**SOLAR POWERED RRFB
(NO. 1)**

ADDENDUM 2		
2	4/20/26	REVISE NOTES

SOLAR POWERED RRFB, AS PER PLAN (NO. 2)

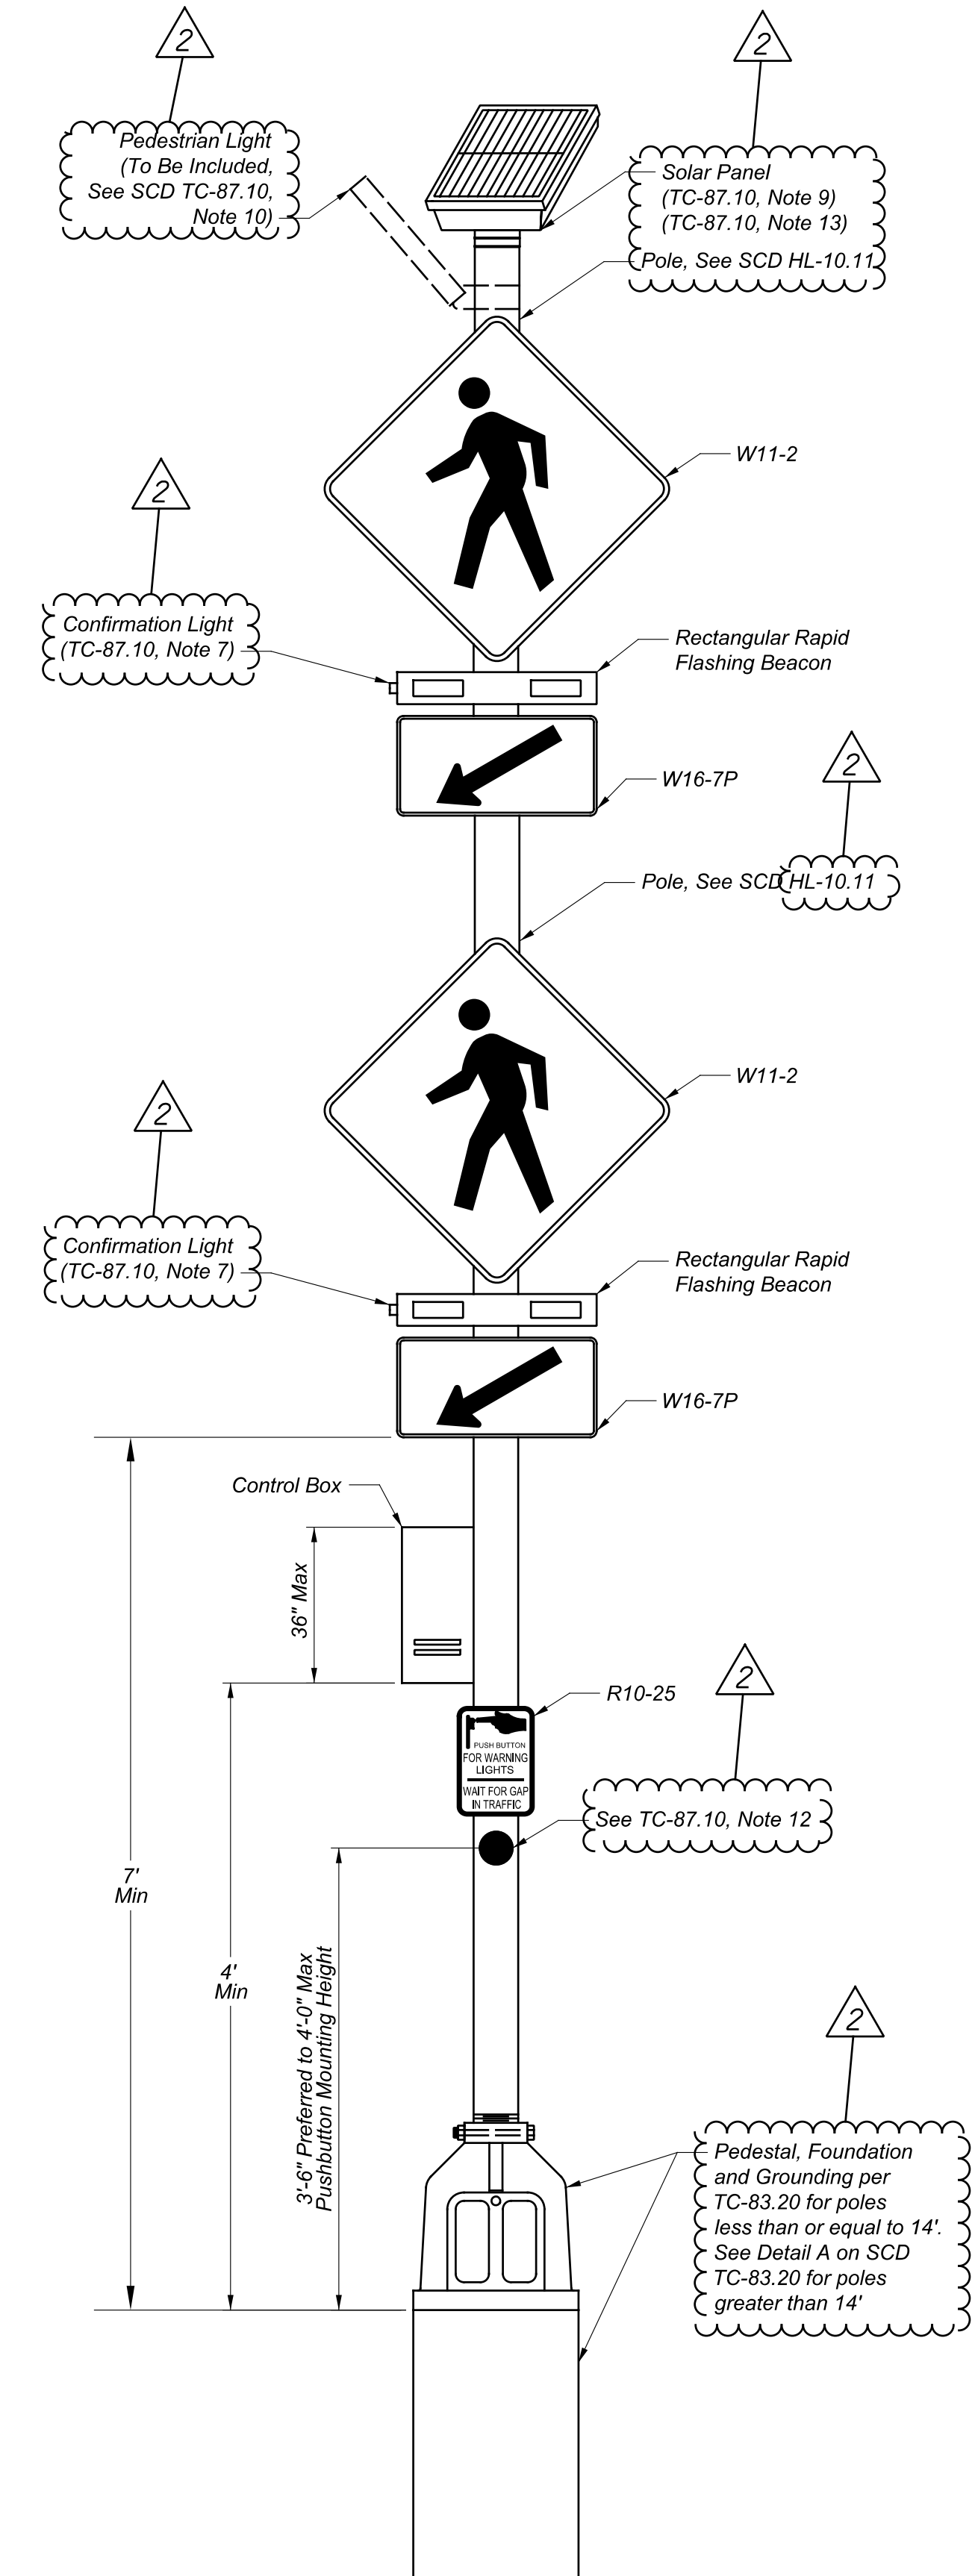
ADDENDUM 2		
2	4/20/26	REVISE NOTES

ITEM 630 - SIGNING MISC.: SOLAR POWERED RECTANGULAR RAPID FLASHING BEACON (RRFB) SIGN ASSEMBLY (NO. 2)

THIS WORK SHALL CONSIST OF FURNISHING AND INSTALLING A SOLAR POWERED RECTANGULAR RAPID FLASHING BEACON (RRFB) SIGN ASSEMBLY. THE FLASHING UNIT SHALL BE 2-SIDED LED, SOLAR POWERED AND PEDESTRIAN ACTIVATED. MULTIPLE UNITS SHALL BE WIRELESSLY CONTROLLED AND SYNCHRONIZED. THE UNIT SHALL BE COMPLIANT WITH THE MOST CURRENT OHIO MANUAL OF UNIFORM TRAFFIC CONTROL DEVICES (OMUTCD) AND SCD-87.10.
